VIRGINIA POLYTECHNIC INSTITUTE AND STATE UNIVERSITY
PROCUREMENT DEPARTMENT

ADDENDUM NO. 5

DATE: June 5, 2026
TO: All Offerors
FROM: Kim Widrig, Contracting Officer
TOTAL PAGE(S): 6 pages (not including attachments)
SOLICITATION TITLE: Improve Center Woods Complex
SOLICITATION NUMBER: 049302624

E201
ELECTRICAL POWER FLOOR PLANS

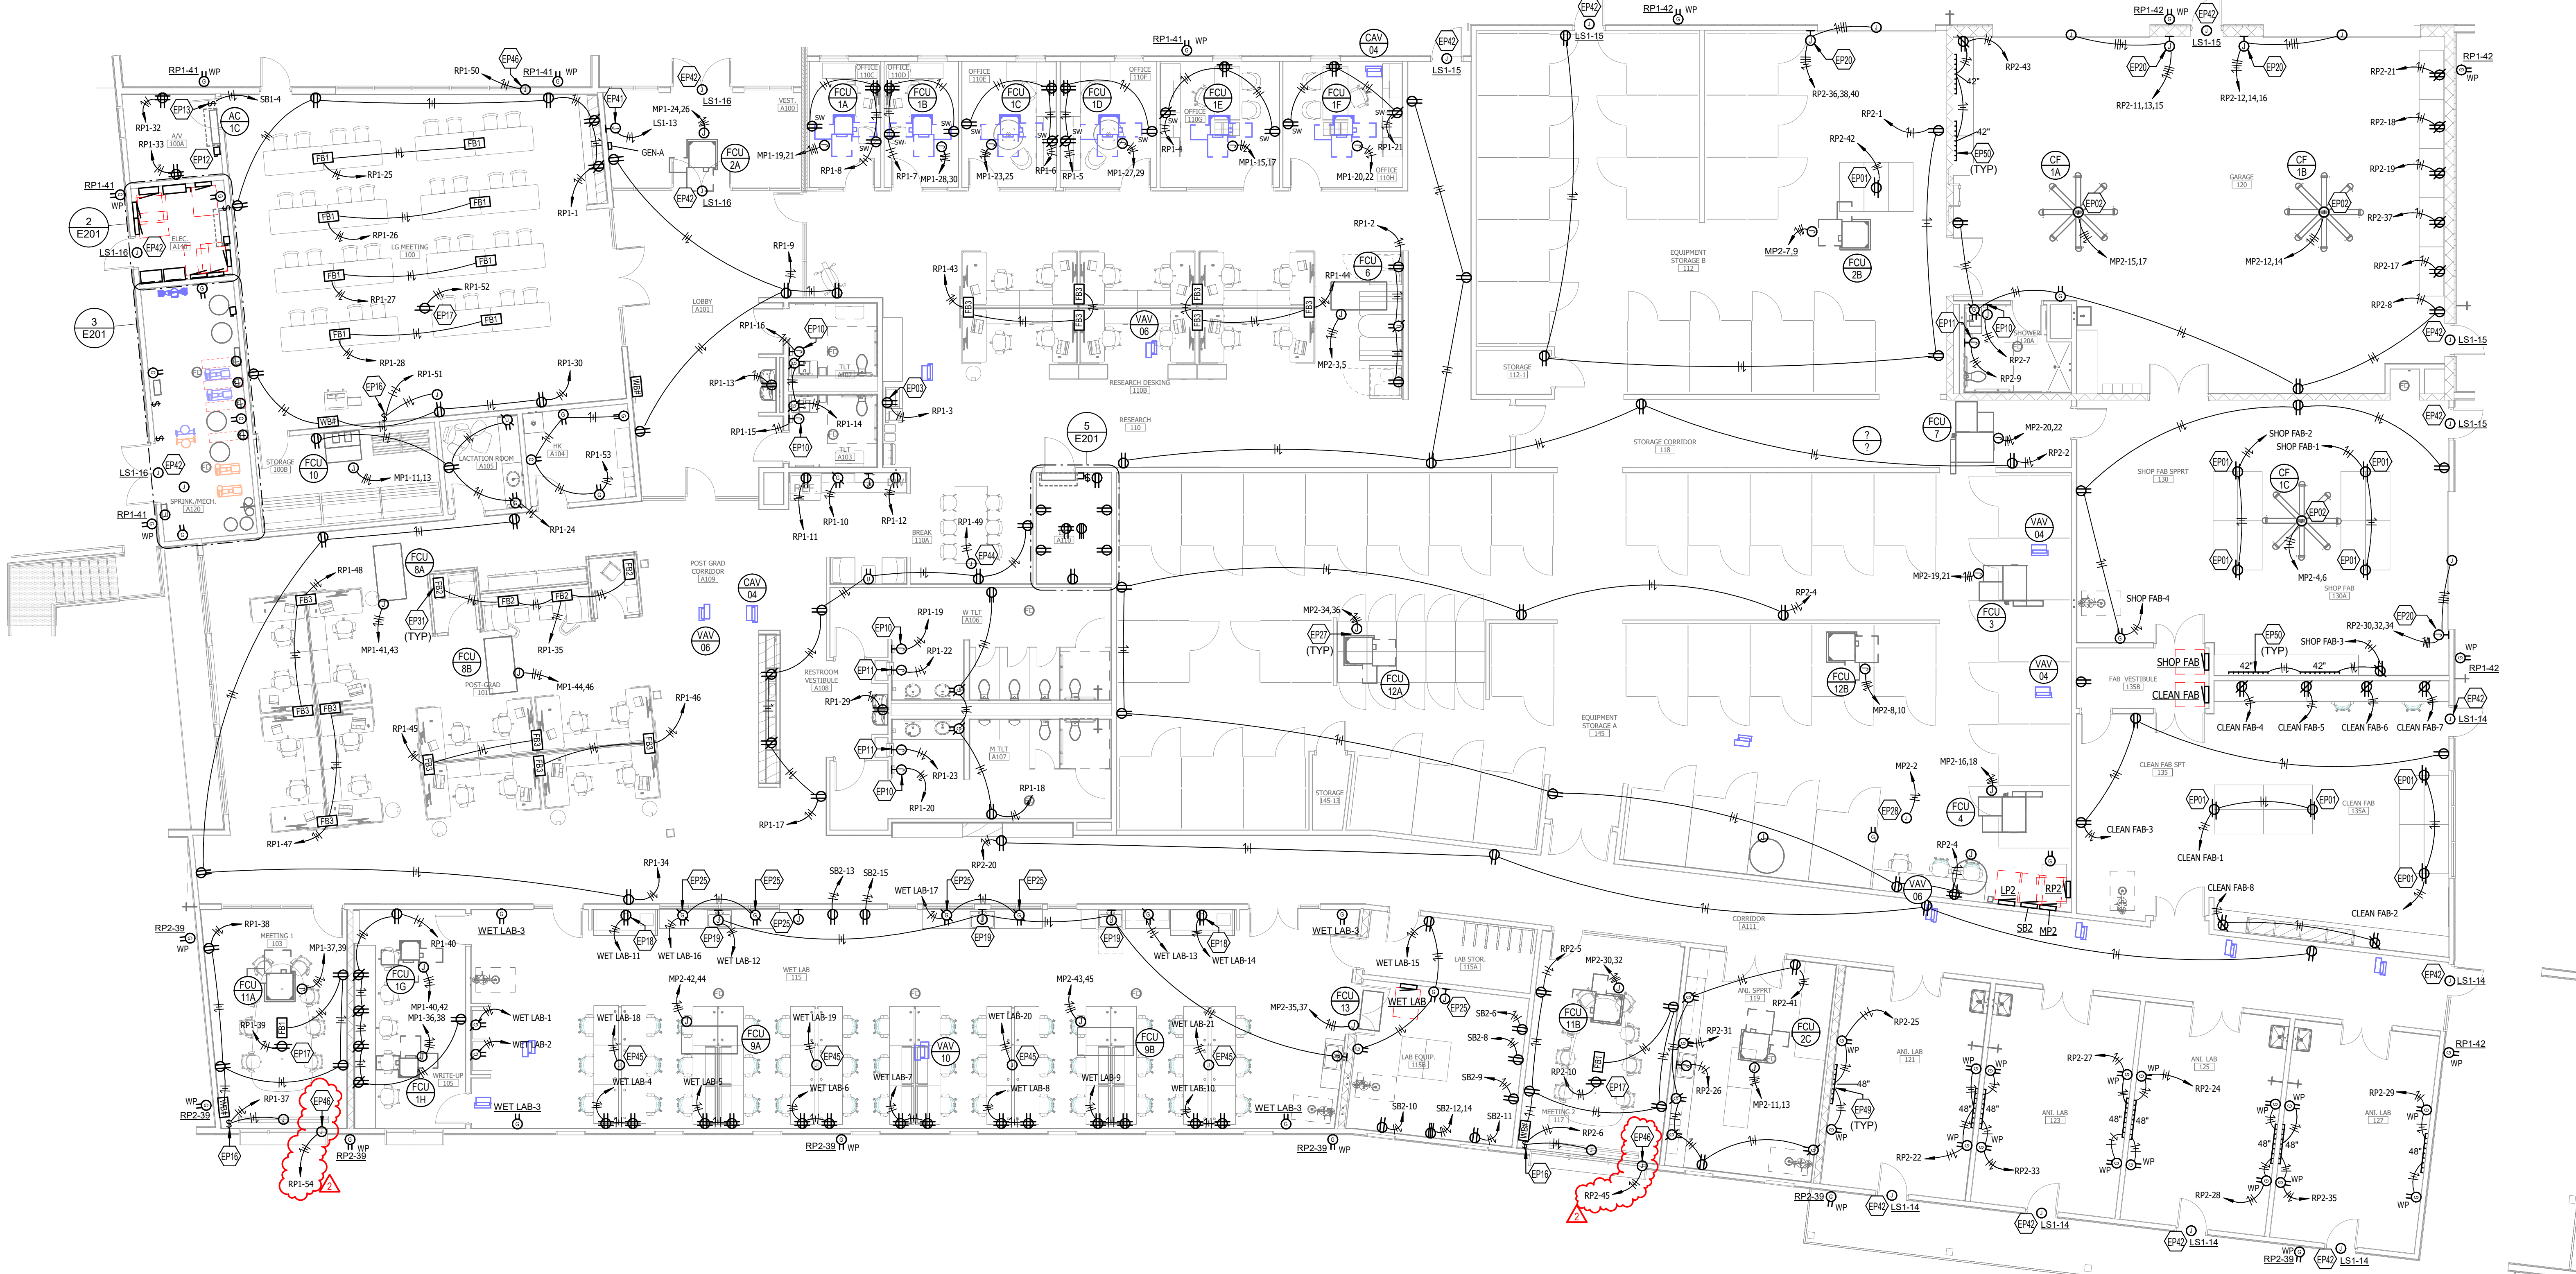
E3: Added 120V connections for motorized shades in Meeting 1 103 and Meeting 2 117. Refer to sheets E201 and E702.

39. On E201, <EP46> is not shown at [103, 117]. Please clarify and coordinate to eliminate scope gap.

Virginia Tech Response: *Connections and associated notes have been added to account for meeting room motorized shades. Sheet E201 is attached herein in **Exhibit A**.*

EP46 PROVIDE 120V CONNECTION TO MOTORIZED SHEDS. EXTEND CIRCUIT TO MULTIPLE MOTORS AS REQUIRED. COORDINATE INSTALL WITH SHADE VENDOR.
